Re: Interpretation for RZ 2008-PR-009 and SEA 80-P-078-15; INOVA Health Care Services: building footprint, building setback, internal circulation, retaining walls, transformers, building height.

Re: Request for Interpretation
Inova Fairfax Hospital Campus
RZ 2008-PR-009/SEA 80-P-078-15

INOVA FAIRFAX HOSPITAL CAMPUS
WOMEN'S HOSPITAL AND SOUTH
PATIENT TOWER BASE FOOTPRINT
COMPARISON

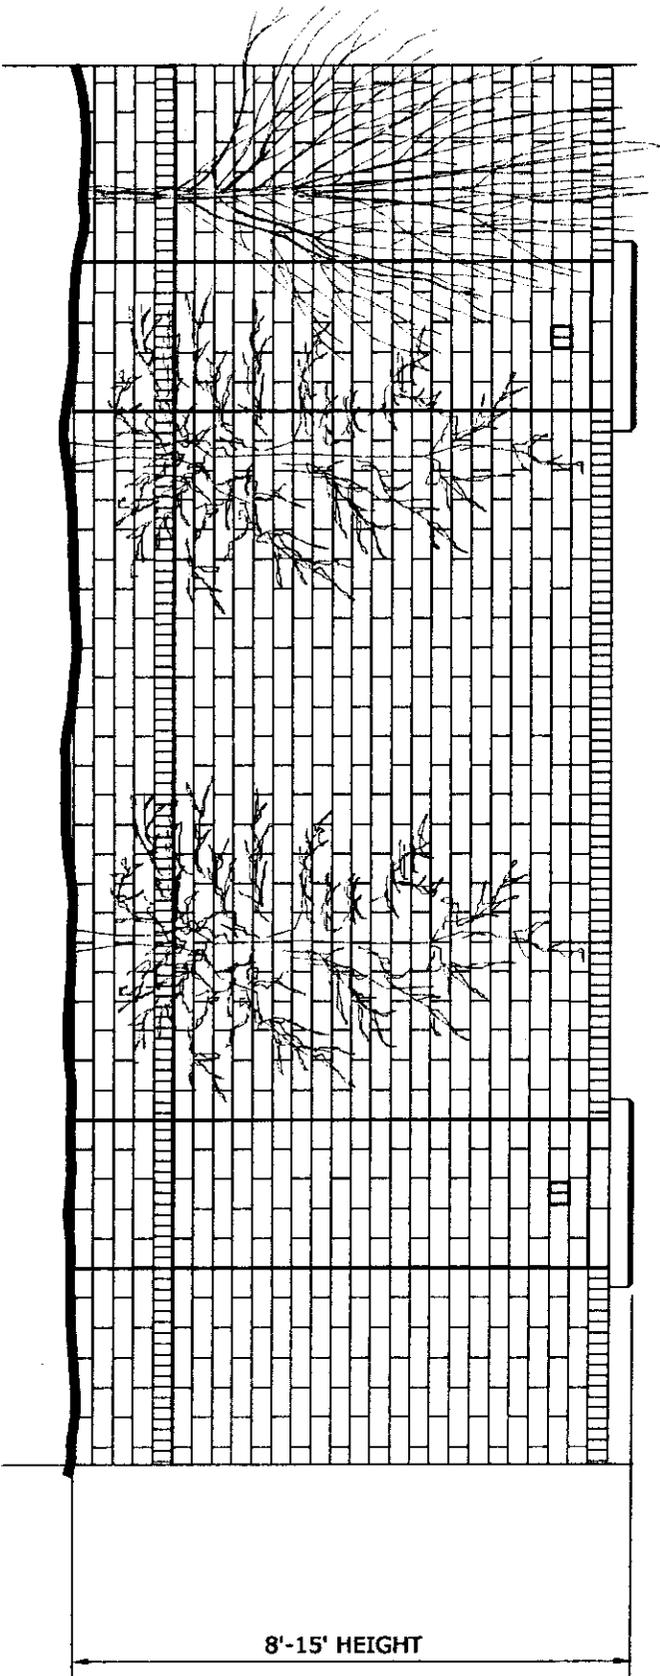
(1) Your first question is whether a minor adjustment to the building footprint and orientation of the approved WHPT would be in substantial conformance with the proffers, the GDP/SEA Plat and development conditions. As shown on your submitted exhibit, comparisons are provided of the base footprint of the approved WHPT with the proposed footprint adjustments. A slight increase of 2.7% in area would result in the footprint adjustments from 111,353 square feet to 114,428 square feet. The proposed building footprint adjustments would not result in material changes in the location of the WHPT relative to surrounding properties or exceed the maximum gross floor area of the WHPT. However, the proposed changes in the building footprint would result in minor changes to the configuration of the patient drop area of the WHPT, including the alignment of curbing along the adjoining private driveway.

3. You requested information to better understand the changes to the footprint of the building. I have enclosed an exhibit that provides a comparison of the approved and proposed building footprints. As you will see, the proposed adjustments to the footprint result in a minimal increase of 2.7% to the area of the approved footprint. This small adjustment is well within the 5% tolerance anticipated by Note 19 of the approved GDP/SEA Plat.

It is my determination that the proposed adjustment to the footprint and orientation of the approved WHPT would be in substantial conformance with the proffers, the GDP/SEA Plat and development conditions, provided the approved maximum gross floor area is not exceeded.

ILLUSTRATIVE DETAIL
OF
SERVICE AREA SCREENING WALL

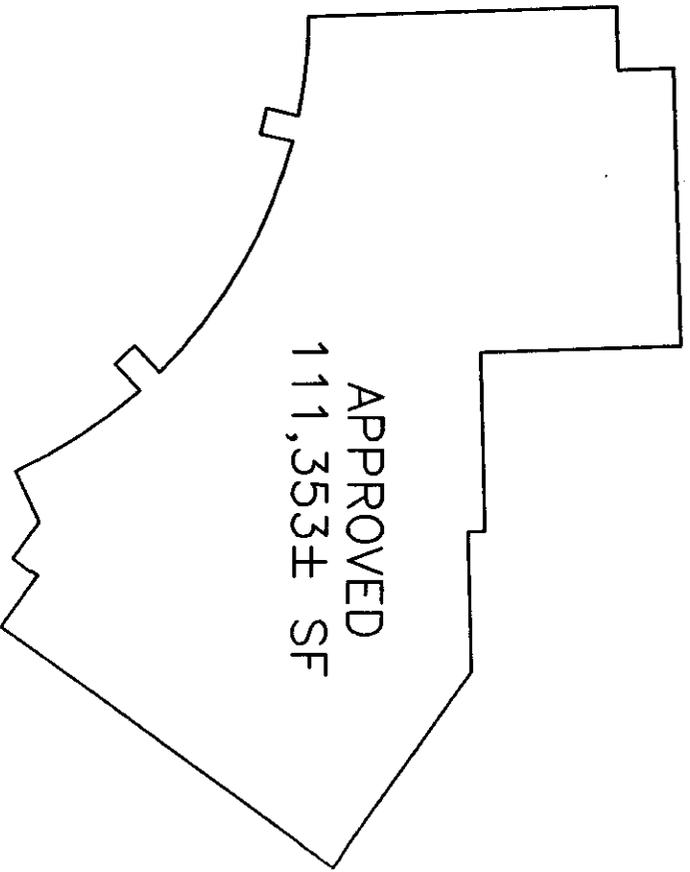
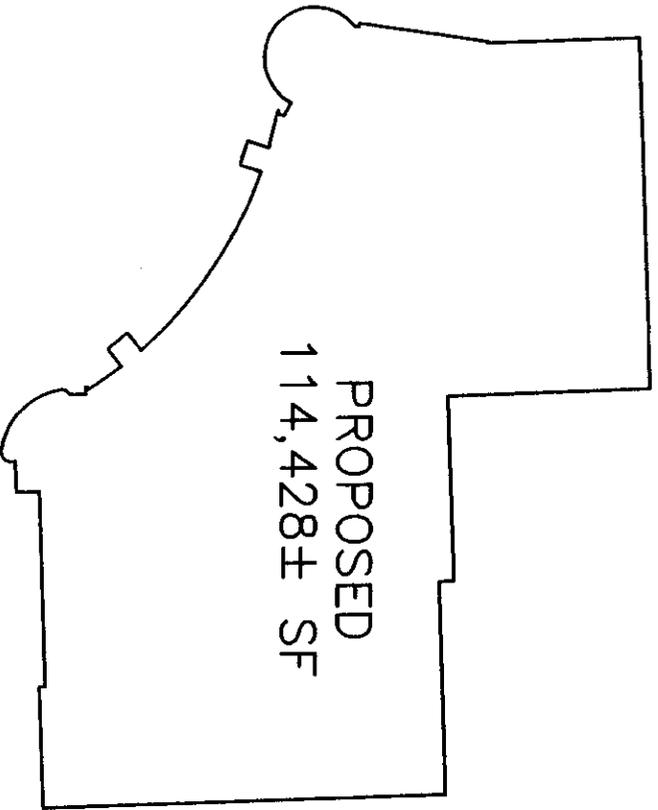
2. You asked for additional detail on the screening wall. I have enclosed an illustrative detail of that.

It is my determination that the proposed adjustments to the retaining walls would be in substantial conformance with the proffers, the GDP/SEA Plat and development conditions, provided that any displaced vegetation is replanted along portions of the retaining walls to ensure adequate buffering, as determined by Urban Forest Management, DPWES.
